Technical Service Bulletin

57F5 UPDATE – Door Pad (NVLW)

December 03, 2014

Model(s)	Year	VIN Range	Vehicle-Specific Equipment
Audi Q7	2015	See Campaign/Action screen in Elsa	None

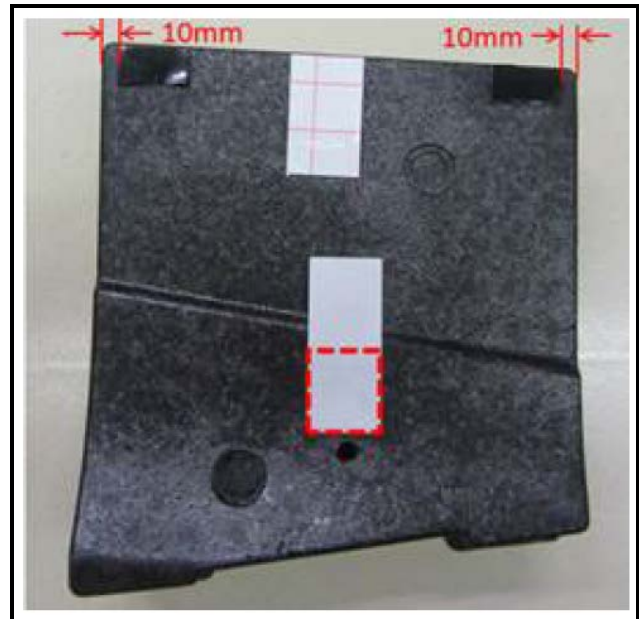
- The pad legs must be modified. 15 mm of width must be removed.

7. Using a razor knife make a horizontal cut flush with the pad body and 15mm deep. Also make an intersecting vertical cut 15mm from the outer face of the pad. Remove the cut-out.
